## Product Change Notice (PCN)

**Subject:** Change PCB Supplier for Flow Sensors Products

**Publication Date:** 7/1/2021

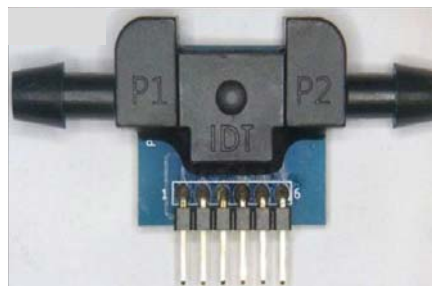
Renesas is changing to a new PCB supplier as a result of the current PCB supplier had discontinued the business for flow sensors products. Refer below table for the comparison of the current supplier versus the new supplier as well as the comparison of the current solder mask versus the new solder mask.

The change will have no impact on the function, quality, reliability and environmental compliance of the products. However, the form and fit are changed as depicted in page 1.

Solder mask color where blue denotes new PCB whereas dark blue denotes old PCB.
